Access Compliance Report Public Rights-of-Way (Curb Ramps)

Main Street: N_HAMLIN_ST Cross Street: E_EL_CARMEN_AVE Location: SW

ADA ID: RPAT211020082506 Ramp Type: Type 1 - Perpendicular Diagonal Initial Pass/Fail: Fail Overall Compliance: No Severity Score: 19

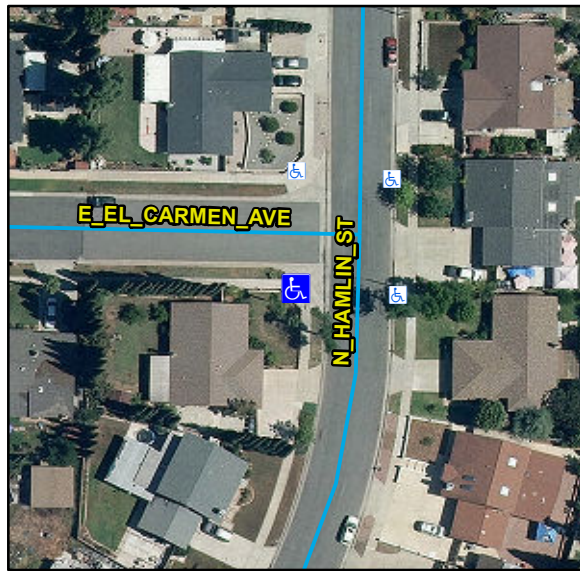
R304.2.2, R204.3, R304.5.1, STD 1115

Remove & Replace Curb Ramp With Two New Directional Ramps or Equivalent.
